1982 Corvette: Service News: Fuel Filter Usage and Installation

Source: Chevrolet Service News

Date: November/December 1982 - Volume 54-6 - Number 12

Fig. 1 — Fuel Filter

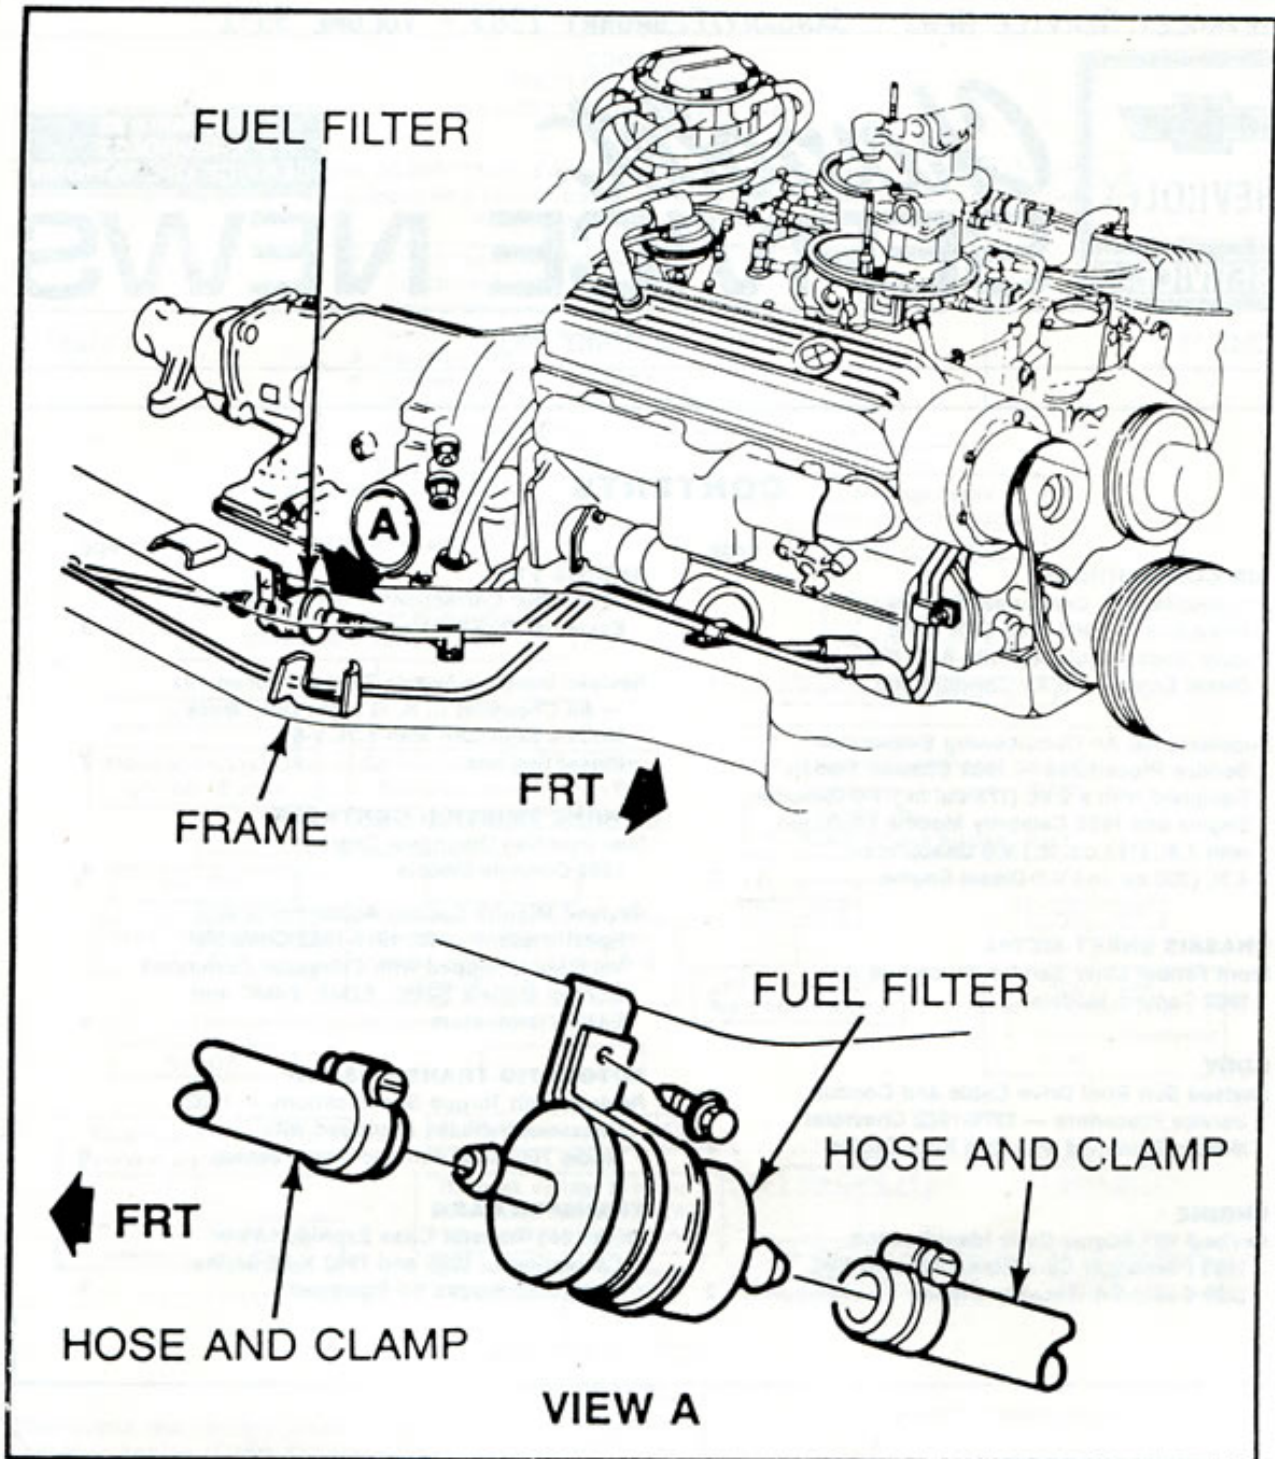
The fuel filter number, GF478, shown on Page 7-2 of the 1982 Corvette Owner's Manual and Figure 6C-3 shown in Section 6C of the 1982 Corvette Shop Manual (ST-364-82) are incorrect. The correct fuel filter number is GF482 and Figure 1 should be used in place of Figure 6C-3 shown in the Corvette Shop Manual.
